# Special Bulletin

# SP15-310

## A/C TUBE AND HOSE PROTECTION Prevost vehicles

Figure 1

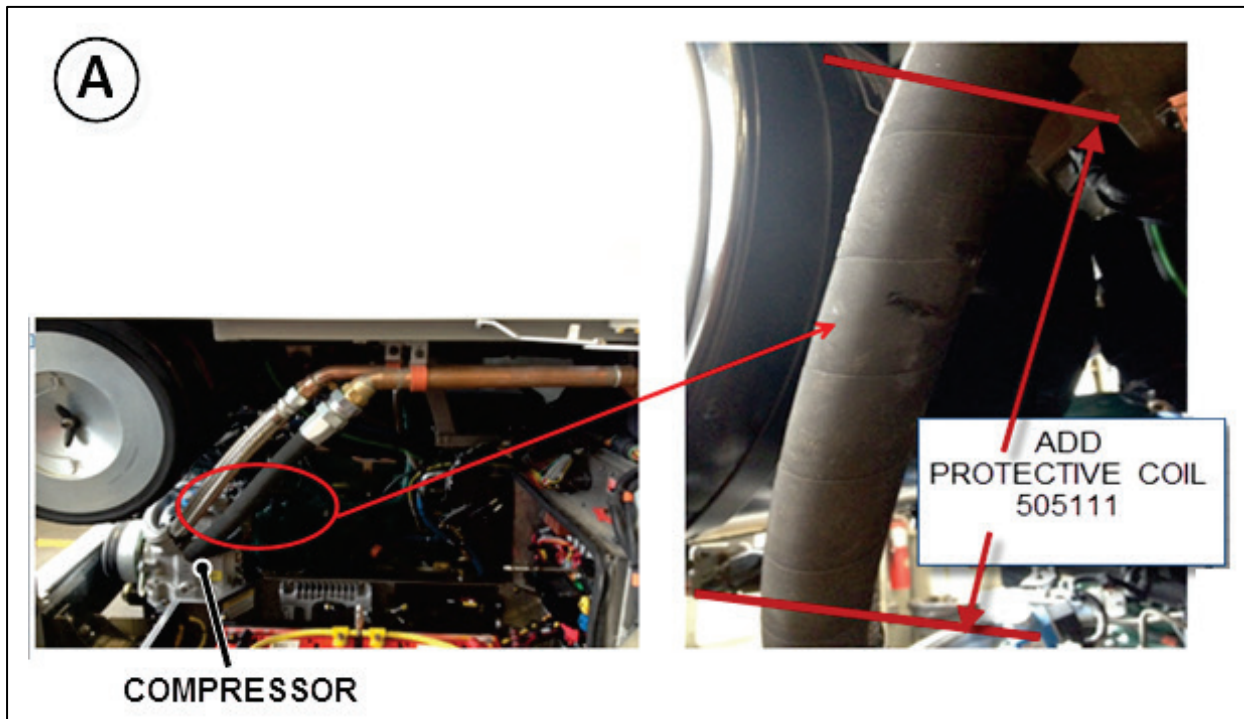
Add protective coil #505111 in area shown in fig.1. Secure the coil ends with multiple turns of electrical tape.

**Figure 2**

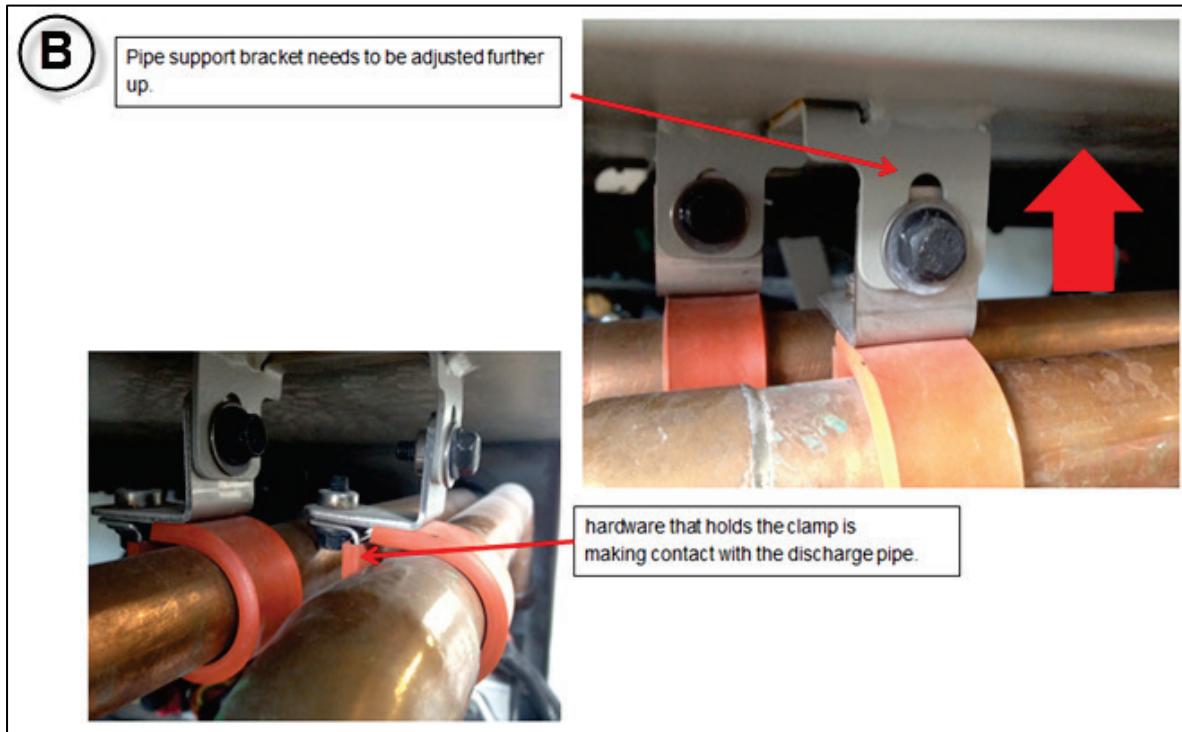
Move pipe support up to clear discharge pipe.
